DATE: AUGUST 24, 2026

ADDENDUM NO.: 2

PROJECT: A NEW BRANCH OFFICE
1208 Texas Research Parkway (SH211)
[211 and Potranco]
(Bexar County)
San Antonio, Texas 78245

SSI – 1 (Addendum-2)

(For loads on main building trusses).

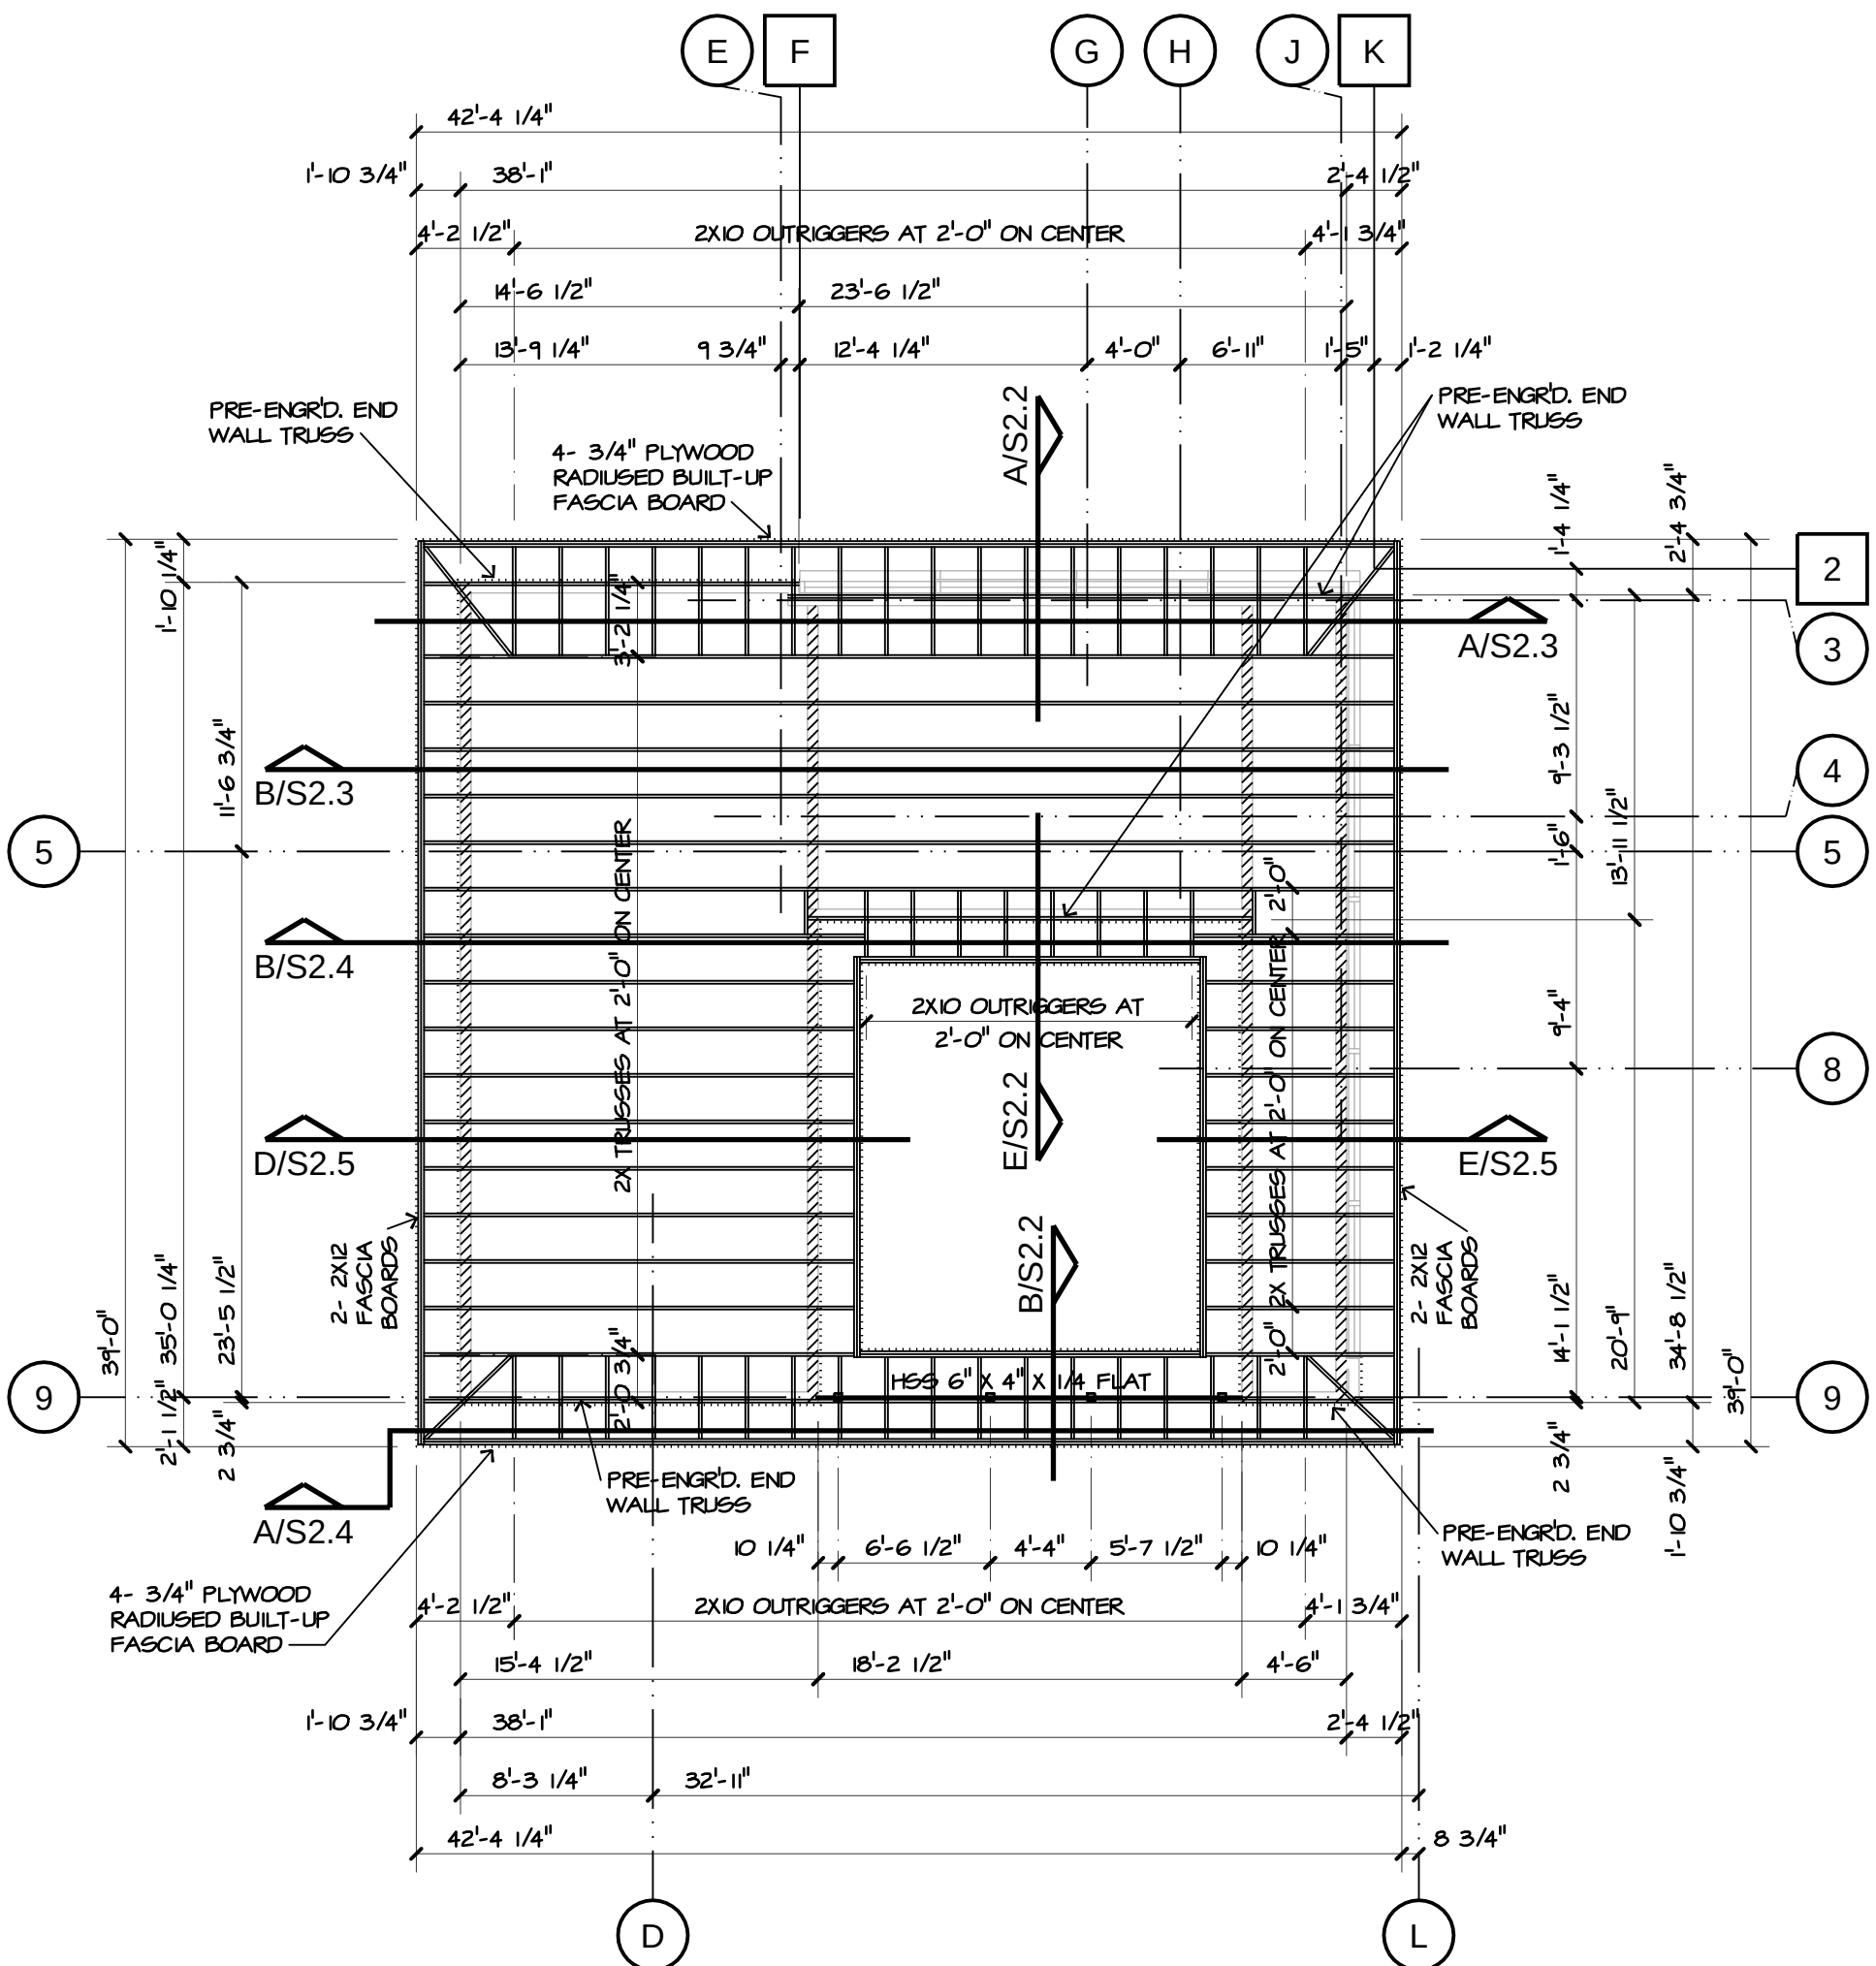
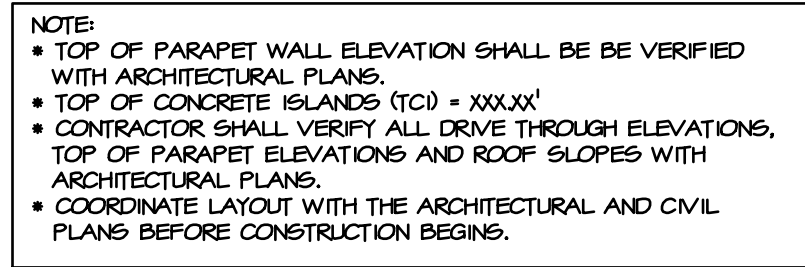
- ITEM 3) Sheet S1.3 – Roof Framing Plans – Changed columns C5 and E5 to C4 and E4 along with the W16x26 beam and omitted grid 5. Moved column C4 into stud wall space and omitted the HSS 4x4 post to roof at grid E4. Refer to Sheet S1.3, SSI-1 dated August 24, 2026.

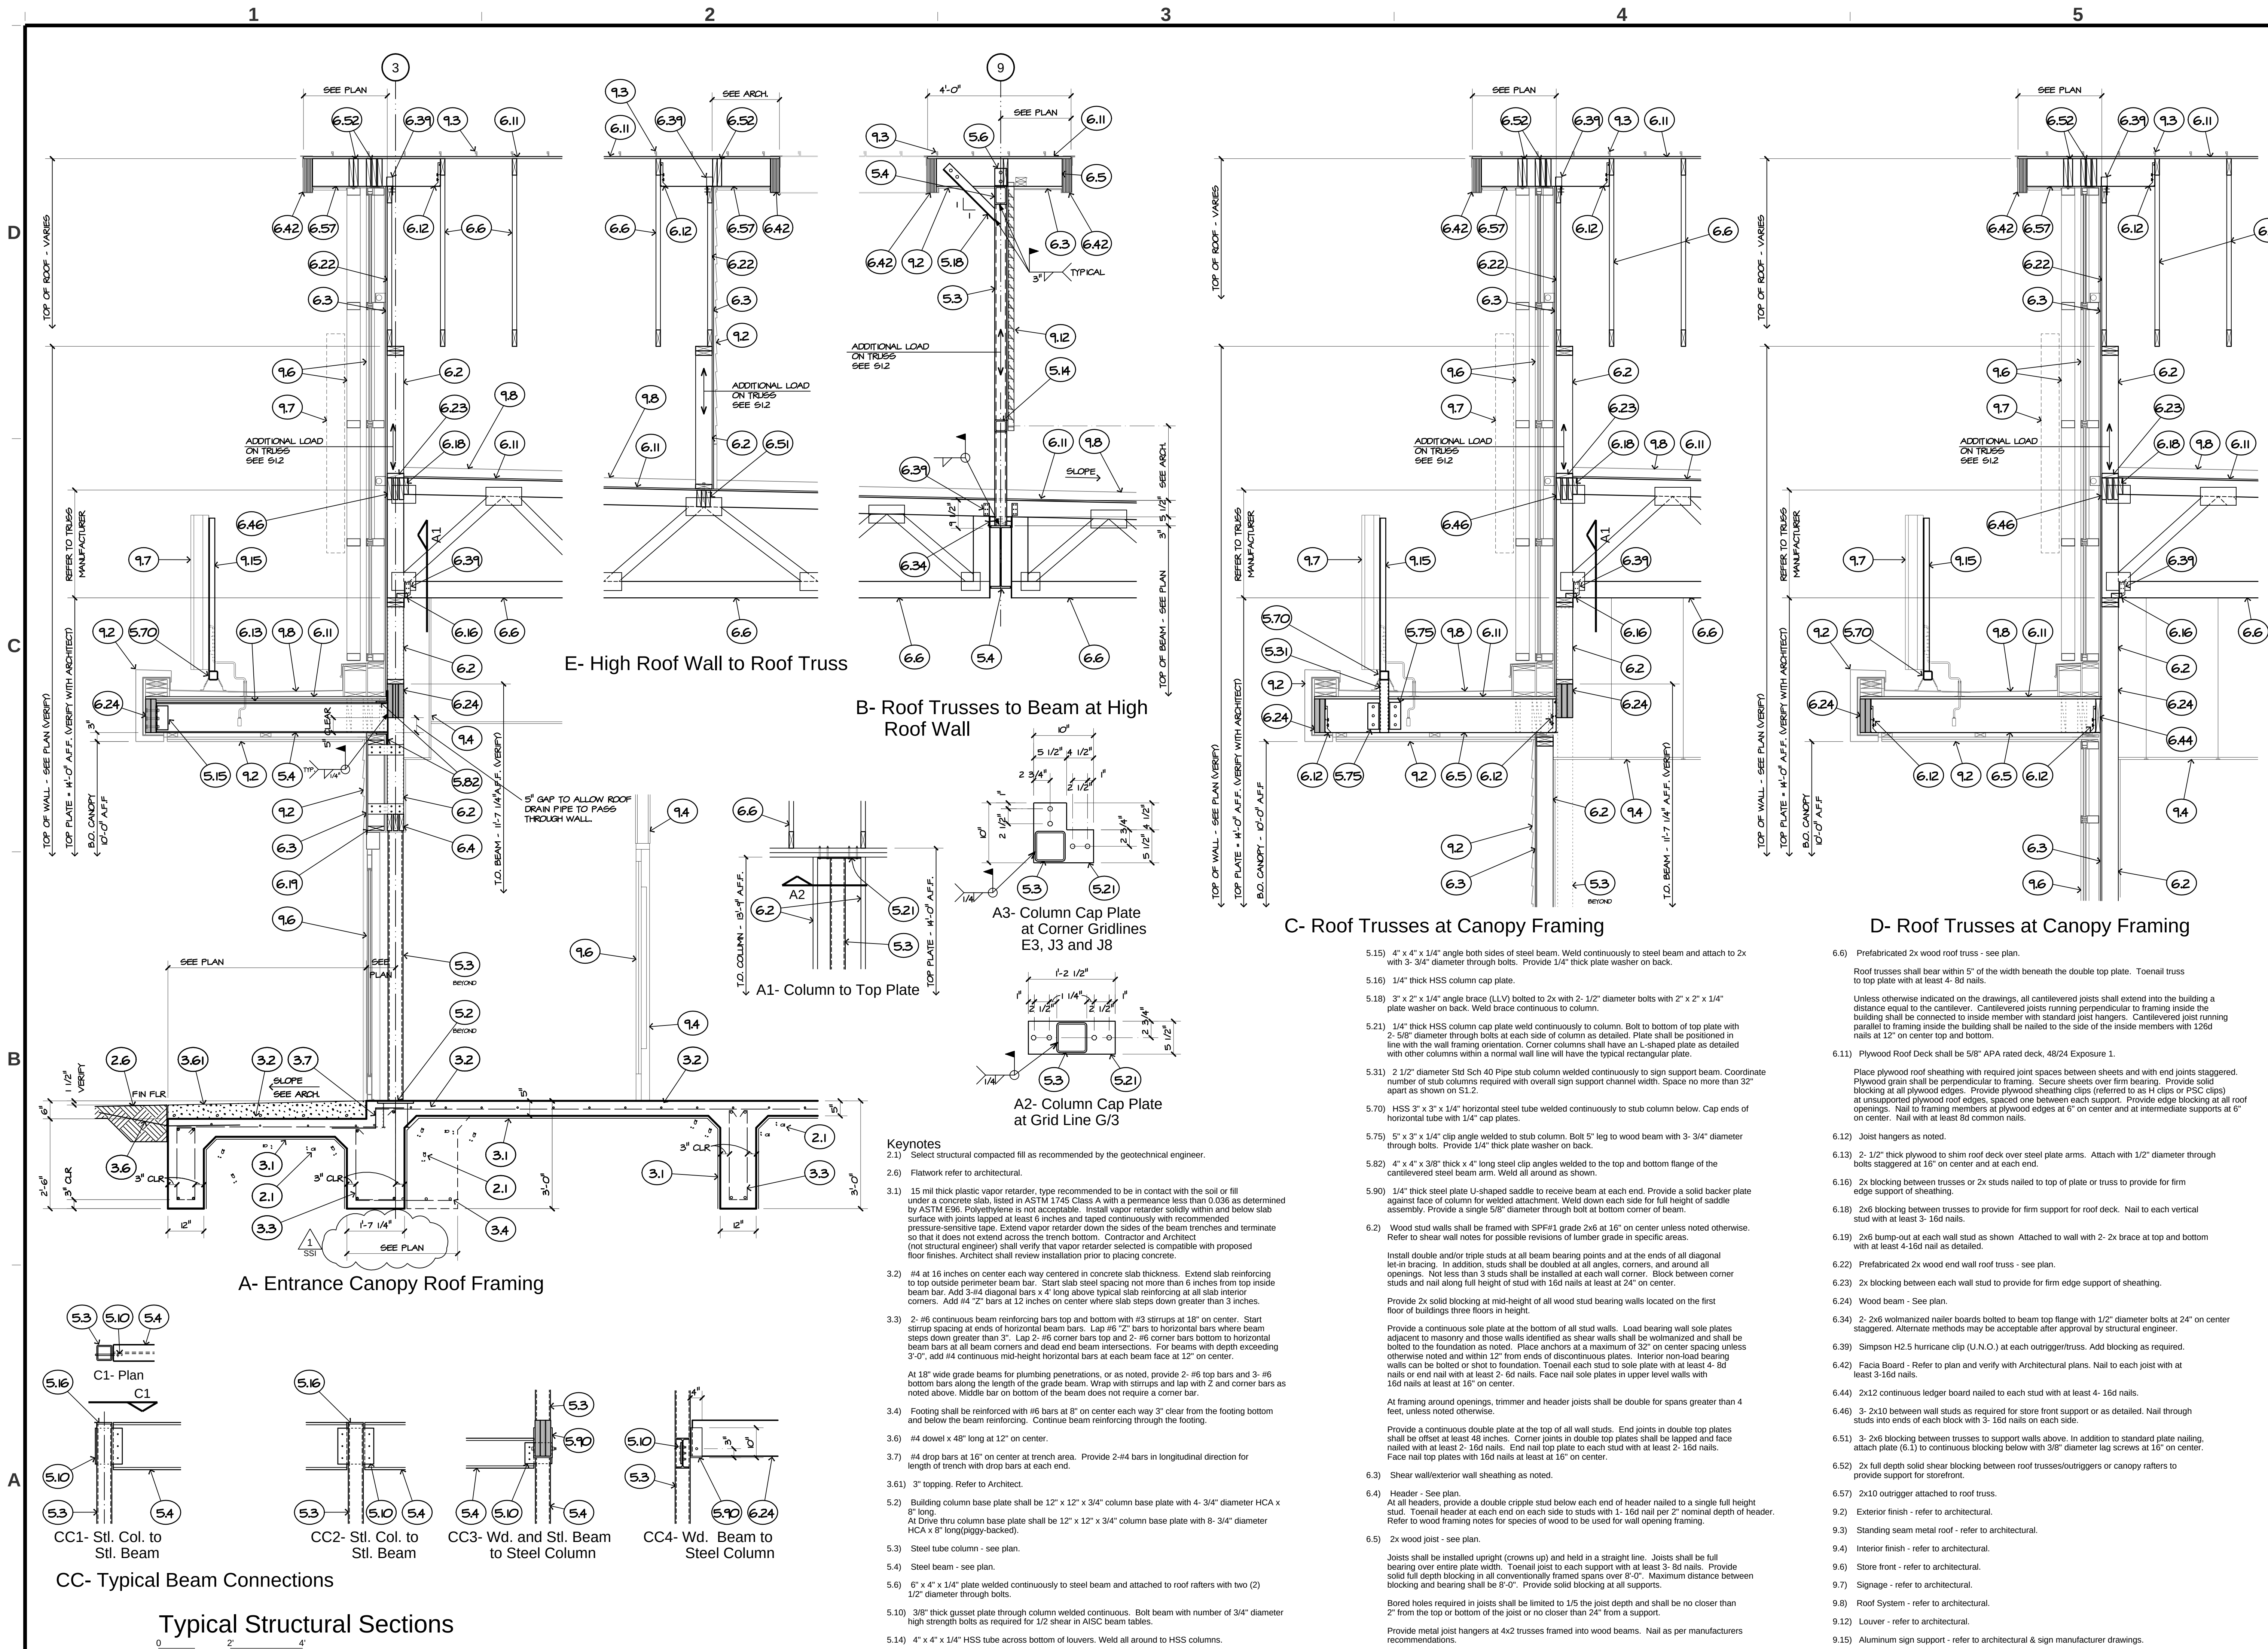
- ITEM 5) Sheet S2.2 – Typical Structural Sections – Revised beam width on section A. Refer to Sheet S2.2, SSI-1 dated August 24, 2026.

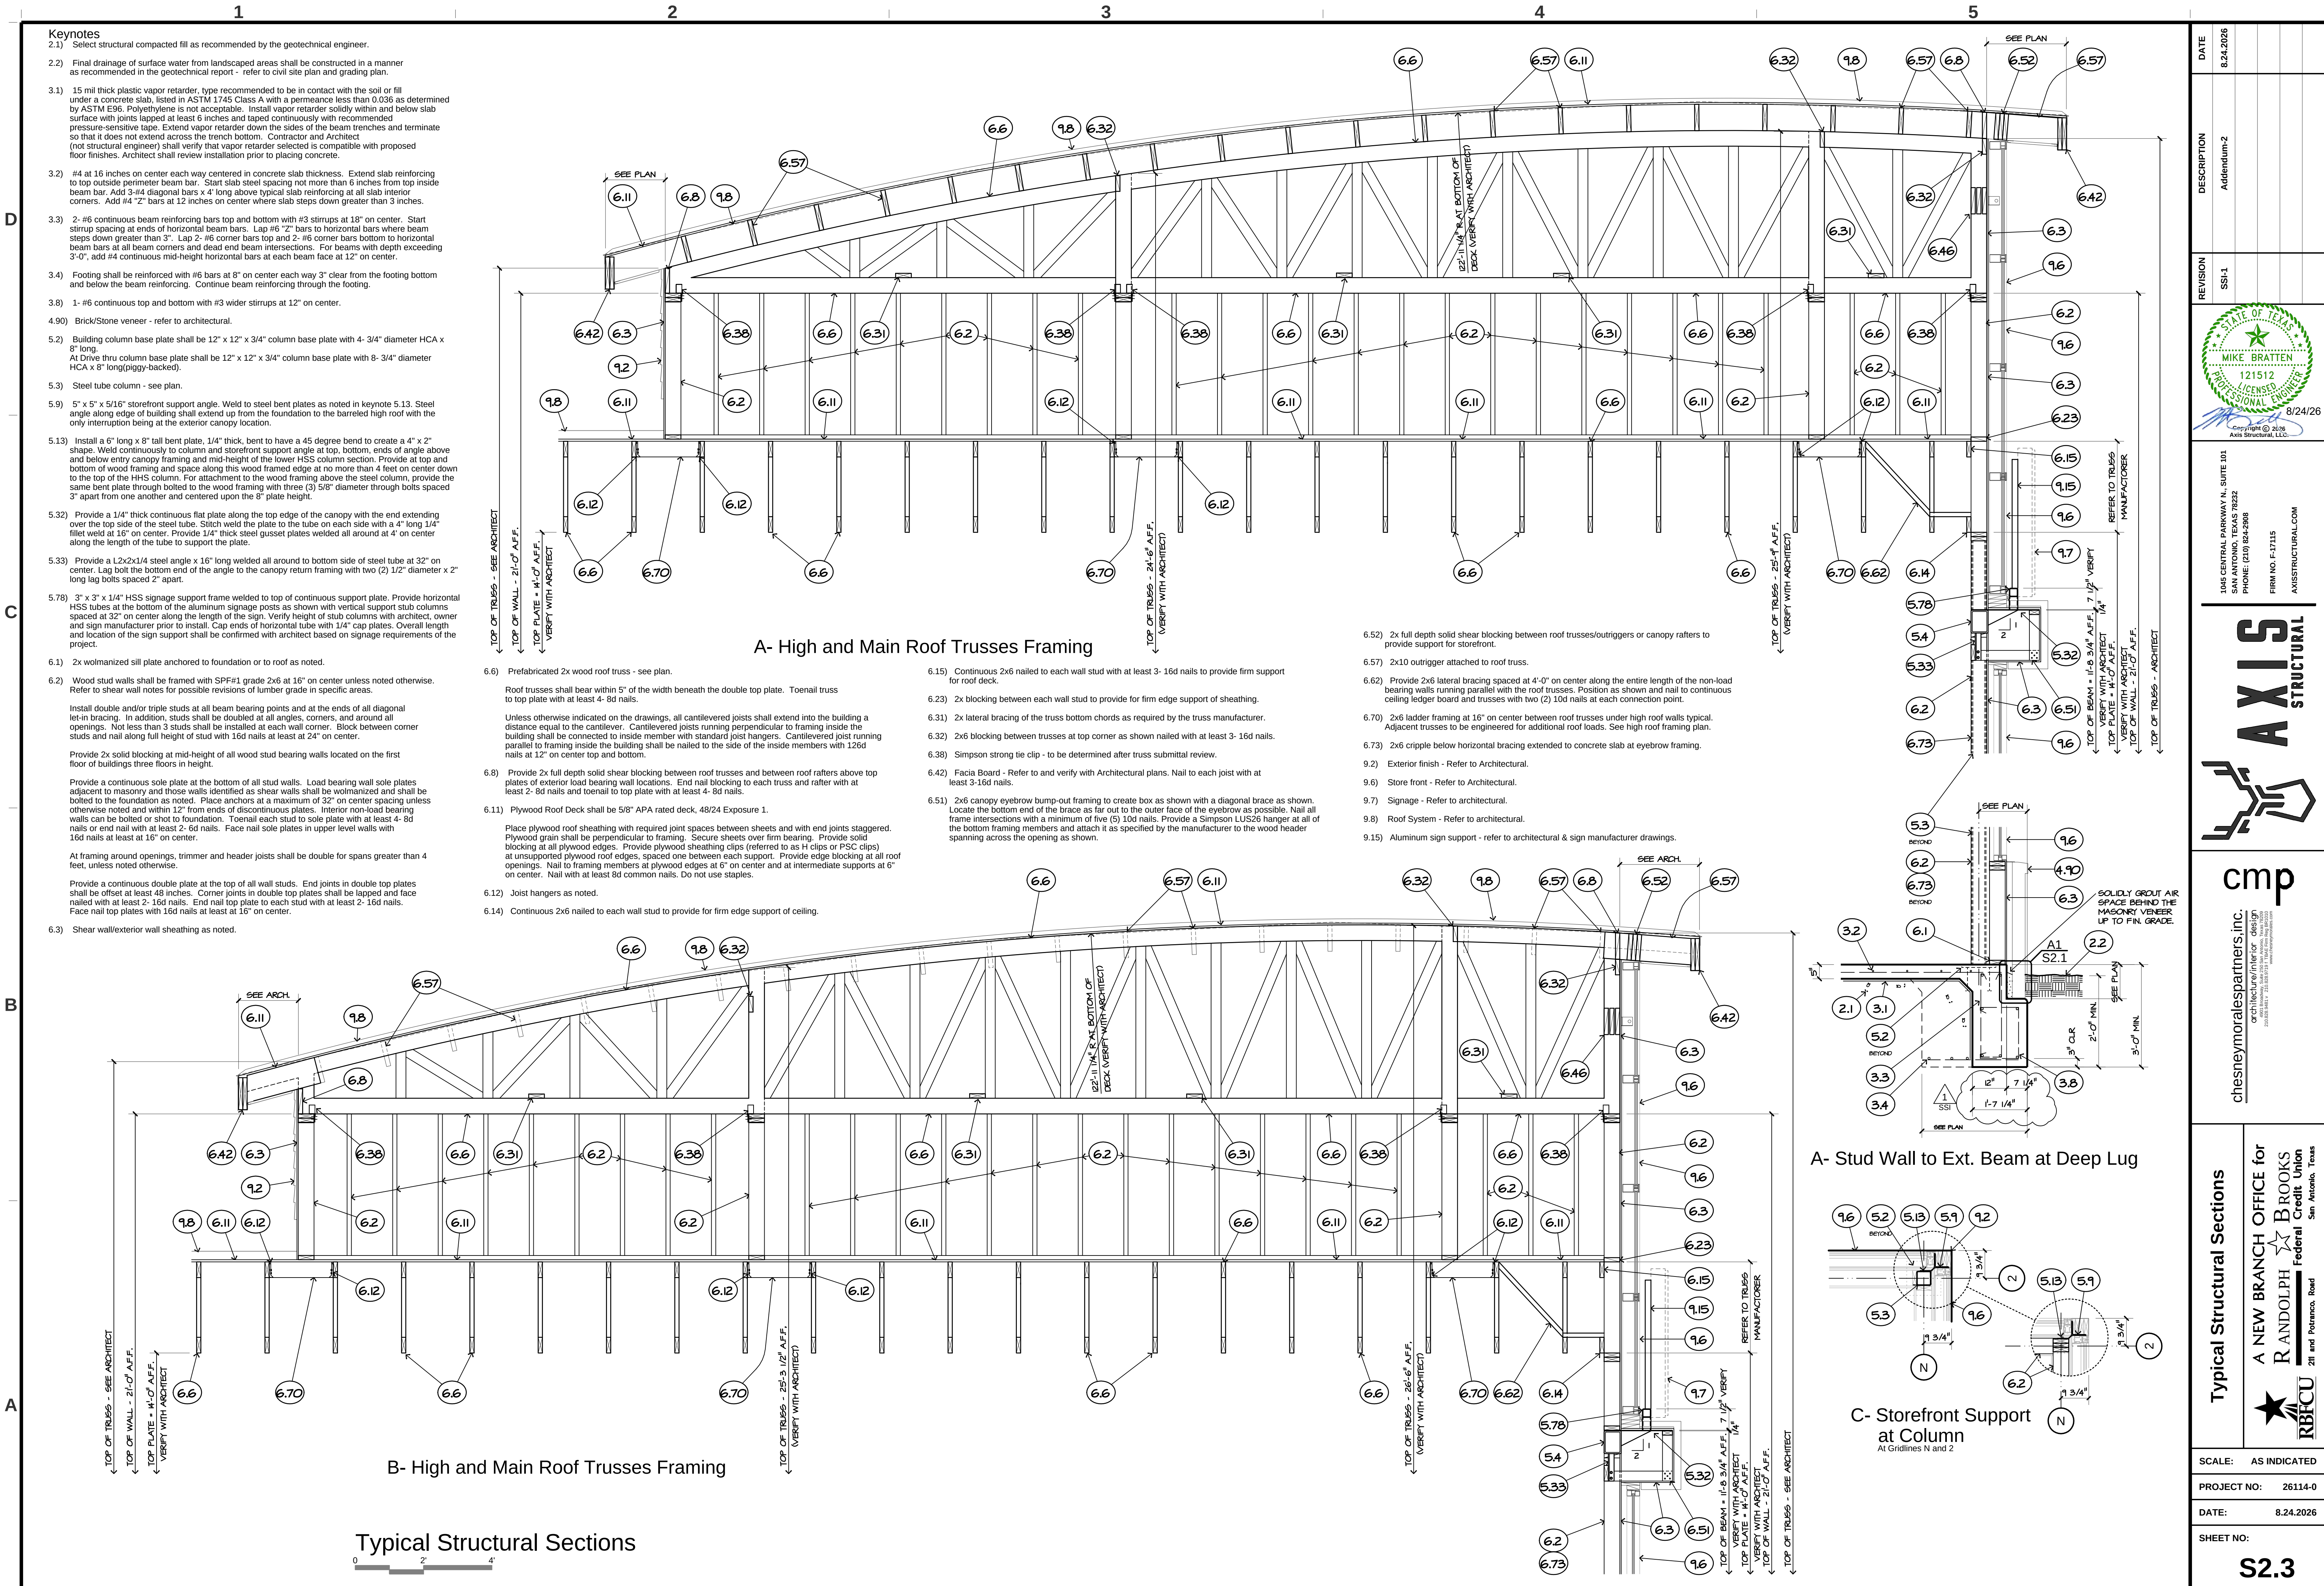
ITEM 6) Sheet S2.3 – Typical Structural Sections – Revised grade beam width on section A.
Refer to Sheet S2.3, SSI-1 dated August 24, 2026.
